## Proposed Changes: ZZ000 FOUR, CLSSY ONE, and PLYYA TWO

Prepared for San Diego Airport Noise Advisory Committee (ANAC)

# CLSSY Standard Instrument Departure (SID)

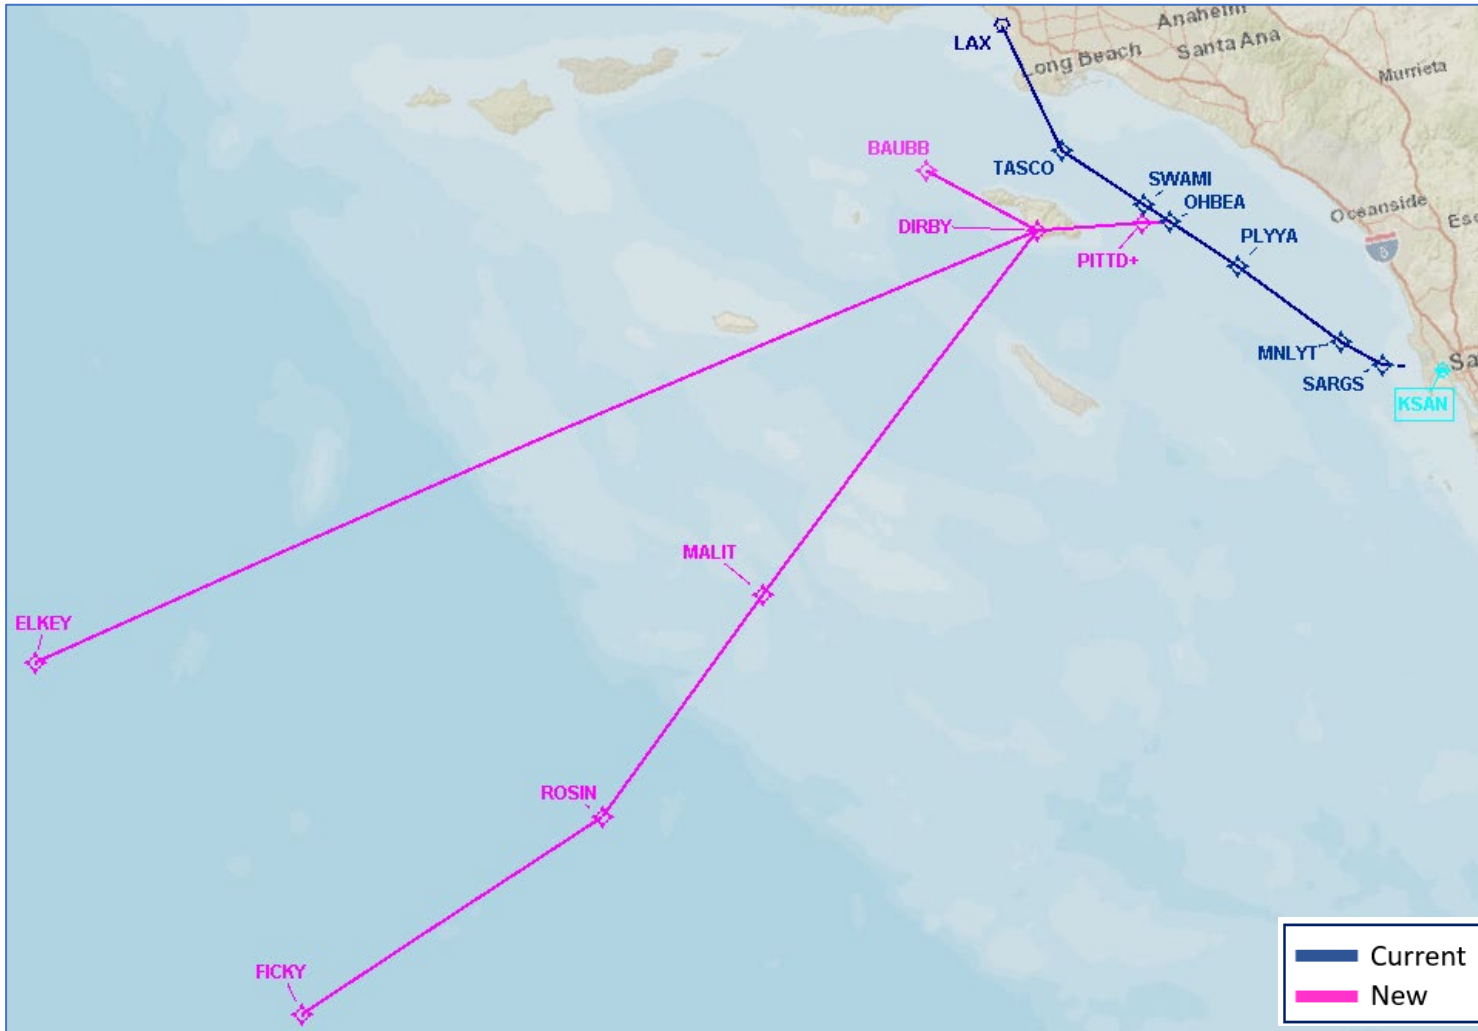
- RWY 27 departures on ZZ000 procedure normally climb direct JETTI or as assigned by ATC.
- For noise abatement, between 2200–0630 local (nighttime), aircraft are assigned 290° heading for vectors to join the ZZ000.
- Proposed CLSSY ONE DEPARTURE (RNAV) procedure would capture existing nighttime vectoring procedures.\*
- CLSSY ONE DEPARTURE (RNAV) procedure would be direct overlay of proposed ZZ000 FOUR DEPARTURE (RNAV) procedure from ZZ000 fix eastward.
